STAFF REPORT

AGENDA ITEM: Wildflower at Lake Elmo Planned Unit Development Amendment

RESOLUTION NO. 2017-048

Exhibit A - Phase 3 Courtyard Lots and Driveway Flexibility

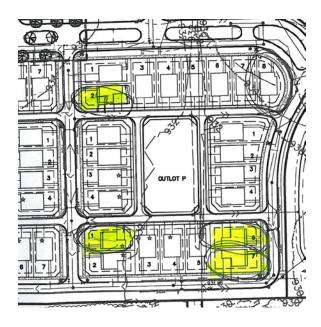
- 3. Allowing Driveway Flexibility on Lots 12, 13 and Lot 17, Block 3, Wildflower 1st Addition; and the highlighted lots in phase 3 shown on Exhibit A below. (Staff Comments) *This request appears to be reasonable in that it is limited to a few lots in the first and third phase of the development. Staff recommends the approval be conditioned on building permit review by the City to ensure there are no unforeseen conflicts or safety issues.*

- o Driveway locations will be flexible on Lots 12, 13 and Lot 17, Block 3, Wildflower 1st Addition; and the highlighted lots in phase 3 shown on Exhibit A
